## ADDENDUM ASSESSMENT REPORT

<b>Panel Reference</b>	<b>PPSSSH-42</b>
<b>DA Number</b>	<b>DA20/0737</b>
<b>LGA</b>	<b>Sutherland Shire Council</b>
<b>Proposed Development</b>	<b>Construction of a new mixed use development consisting of 37 seniors living units and commercial tenancies</b>
<b>Street Address</b>	<b>37 Gerrale Street, Cronulla</b>

**Figure 1 – changes in floor space on the ground floor**

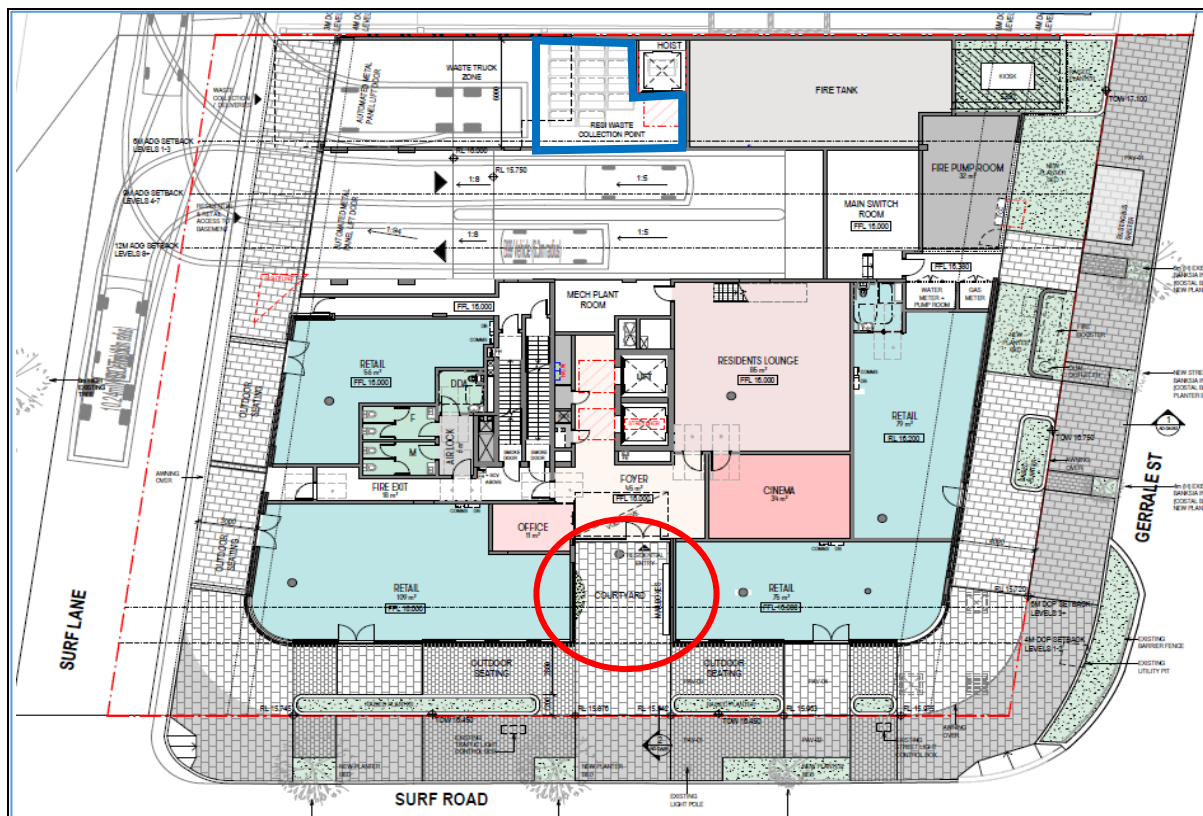
The amended plans submitted for consideration incorporate the inclusion of the area on the Ground Floor (shown outlined in blue on the plan below) for the storage of bins for waste pick up as floor space. With the removal of the ground floor entrance wall and gate (area shown circled in red on the plan below) the amended plans submitted show that the building is compliant with the overall allowable floor space albeit the roof top pavilion is still located on the roof top and is included as floor space.

Figure 2 – indicates the reduced size of the pavilion compared to the original size (hatched in red).

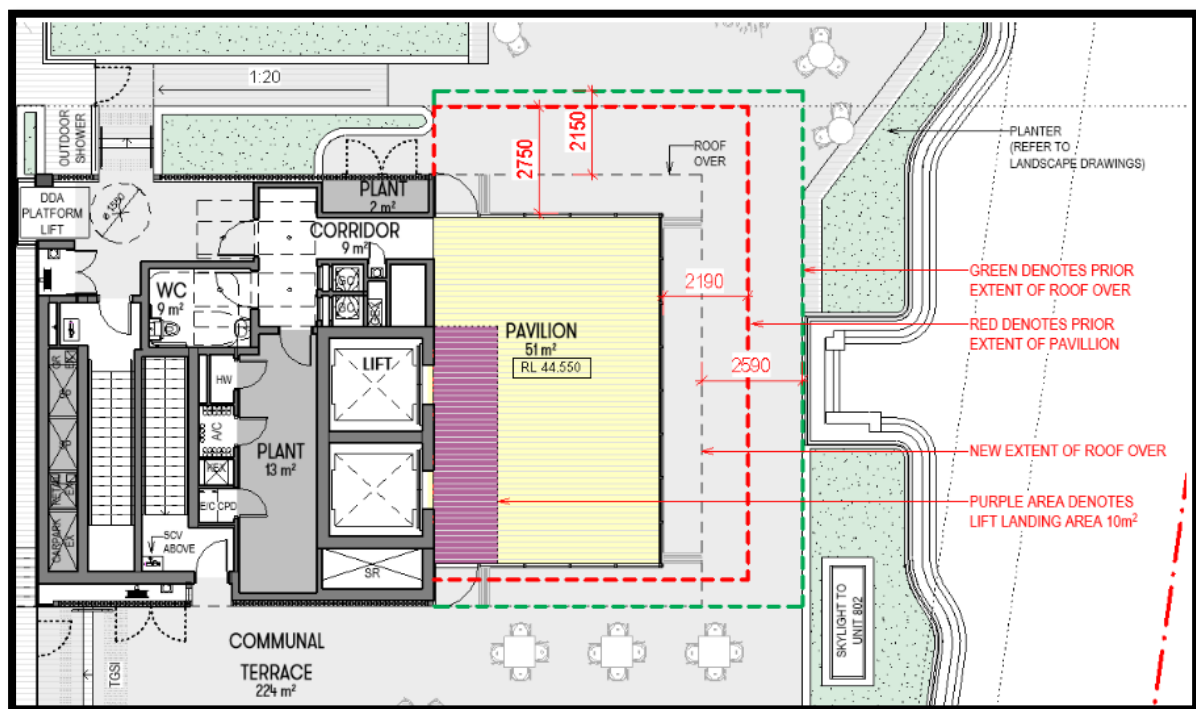
The revisions include reducing the height of the pavilion by 400mm, from RL48.0 to RL47.6 and its area by 40m<sup>2</sup> (from 91m<sup>2</sup> to 51m<sup>2</sup>), this is a 43% reduction from the original size proposed. This is generally in line with the DRF recommendation of setting back roof elements from the perimeter of the building. The reduction in the size of the pavilion which increases the setbacks from the northern and eastern edges of the building, together with setting back the location of the balustrades (and increasing the size of the plater beds) on Level 9 would achieve a satisfactory visual outcome from a north eastern location along Gerrale Street or the east from the Cecil Apartments or south east from Cronulla Park (Figure 2 below). This is not dissimilar to other buildings within Cronulla.

The revised plans show reduced plant areas on Level 9 and the roof (Figure 2 above). Council's original assessment report raised that *there is competition on the roof to accommodate a very large pavilion, vast areas of plant to a point where some elements are also required to be located higher than the pavilion roof which itself breaches the height limit.* The air conditioning units on the roof have been deleted and are to be accommodated in a new mechanical plant room proposed on Level 1. The plant areas on the northern side of the lift/plant/stairs and corridor on Level 9 have been deleted and replaced with an outdoor shower and planter bed.

**Figure 3 - Mechanical plant room proposed on level 1.**

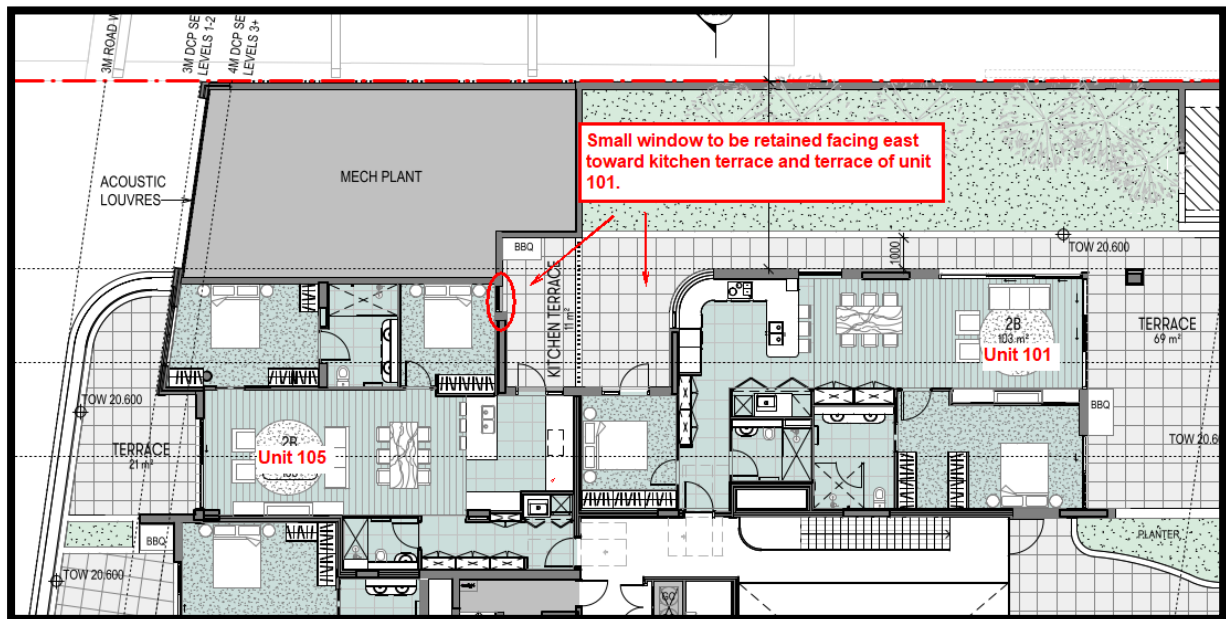
Removing the air conditioning units from the roof is a positive change, as it negates the need for roof service screening which adds to height and bulk. In this design a new large mechanical plant room has been added on Level 1 above the waste truck collection area which can be seen from Surf Lane. This plant room is 2.5m in height and approximately 67m<sup>2</sup> in area. The area is shown with solid walls to the north and east, acoustic louvres on the western elevation face Surf Lane and directly abutting the northern wall of Unit 105.

**Figure 4 - Northern elevation showing increased wall height along the boundary.**

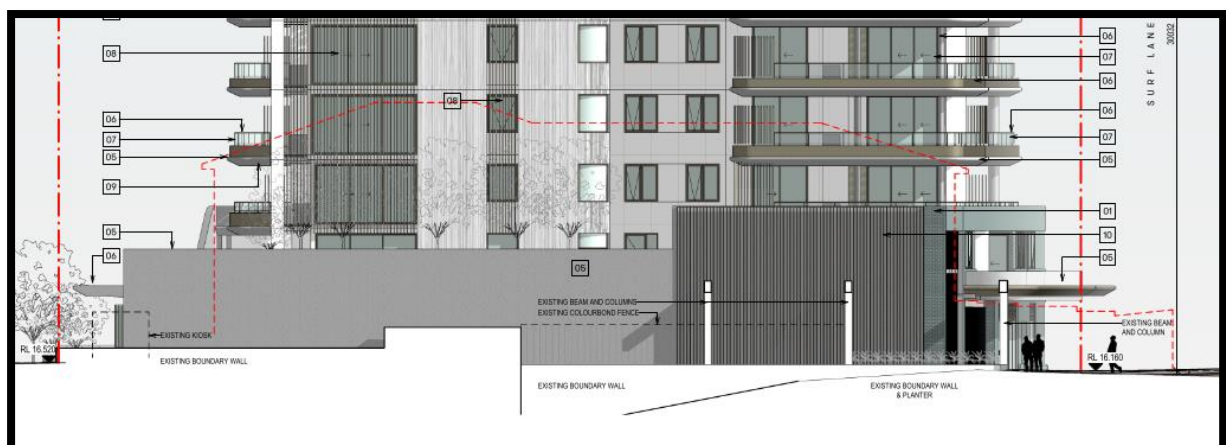
This plant room results in a continuation of the two storey street wall at the boundary facing Surf Lane and a 7.5m high wall at the northern boundary for a length of approximately 12m. The wall steps down to a height of 5.5m for the remaining length of the boundary (to the east) until it reaches the Gerrale street boundary (Figure 4 below).

*'the visual prominence of the 5.5m high white blank wall that extends most of the northern boundary. This will be visible from Surf Lane and Gerrale Street, albeit somewhat screened by the adjoining properties podium level and podium planting ... The northern boundary wall is not an acceptable interface with the neighbouring property and fails to result in an adequate relationship with the established ground level context of the neighbouring development.* The new mechanical plant room will exacerbate the visual prominence of the development when viewed from the lane, northern adjoining property and Units 101 and 105 within the proposed building.

With regards to impacts on units within the development, the northern bedroom windows of Unit 105 have been deleted to accommodate the plant room, leaving bedroom 2 with a very small window facing east toward a kitchen terrace and the terrace of Unit 101. An acoustic report was not provided with the amendments demonstrating that the impact of the mechanical plant room on Units 101 and 105 and the neighbouring property would be acceptable.

Although the revisions proposed reduced plant areas on the rooftop, the new plant location will result in a poor interface with the neighbouring property and visual impacts on Surf Lane. The additional built form does not provide appropriate setbacks from the side boundary. It is in the order of 7m high on a zero setback and faces adjoining private open space to the north. It is a poorly resolved presentation. Therefore, to offset the structure from the open space on the podium located on the northern adjoining property and to mitigate any visual impacts that the property or streetscape may experience, the plant room should be reduced in size and setback a minimum of 2 metres from the northern side boundary with a solid vegetated wall (green wall) facing north and capped with a green roof rather than a pebble roof for the benefit of units looking down at this space.

Landscaping also exists in the south western corner on the open podium of the adjoining building which will provide screening and therefore with the increased setback and green wall directly adjacent to the open podium, will achieve a reasonable outlook for the neighbouring property. The 2m setback is consistent with the setback provided by the northern neighbour at the podium level and will provide a balanced space and transition in height between the two buildings when viewed from Surf Lane.

The reduction in the plant area above the waste collection room is likely to require that some plant be relocated. The plant should be accommodated within the building confines (without increasing height or reducing setbacks of the building) and not on the rooftop as this will increase the height contrary to the latest design modifications. These matters maybe be dealt with via deferred commencement consent conditions to allow for the applicant to reconcile the capacity of the plant room and the extant requirements of the development and the need for any additional plant areas with the building. It will also allow for proper detailed landscape plans to accommodate a green wall to be assessed. Conditions 2, 3, 4, 24, 27 and 28 have been included in the Draft deferred commencement consent reflecting the required changes.

**Figure 5 - Revised height blanket showing structures that exceed the maximum height limit with the original scheme and the revised scheme.**

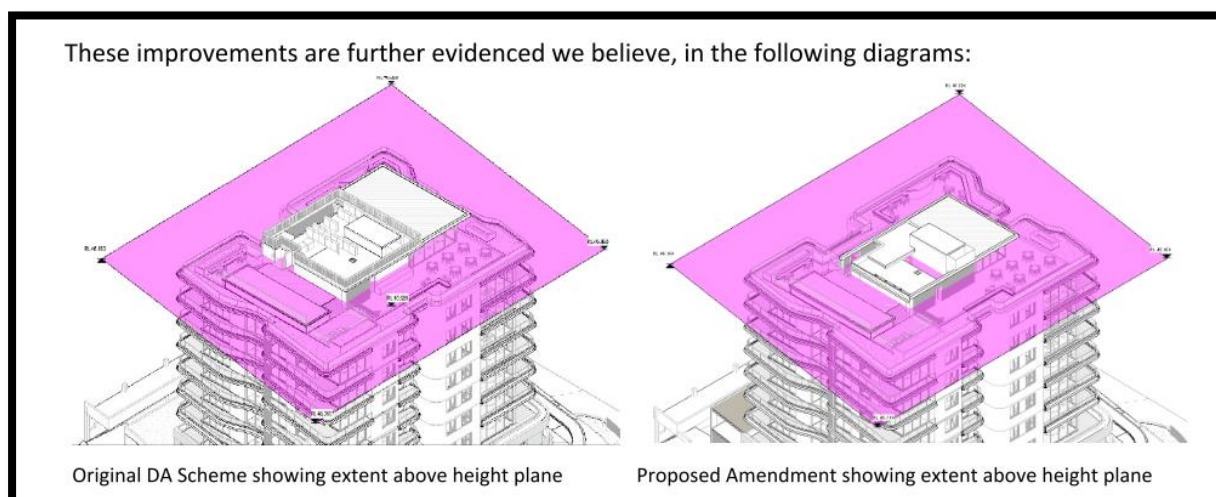
The proposed development fails to comply with the development standard for height. Clause 4.3(2) of SSLEP 2015 stipulates a maximum height of 30m for this site. The proposal seeks a building height of 33m (RL49.00 to lift over run) which exceeds the maximum height by 3m, resulting in a 10% variation. A clause 4.6 has been provided for consideration in support of the non-compliance. The roof elements that exceed the building height standard is the lift over run (RL 49.0) and the roof over the pavilion, stairs and plant at RL 47.6 being 1.5m over the permitted height.
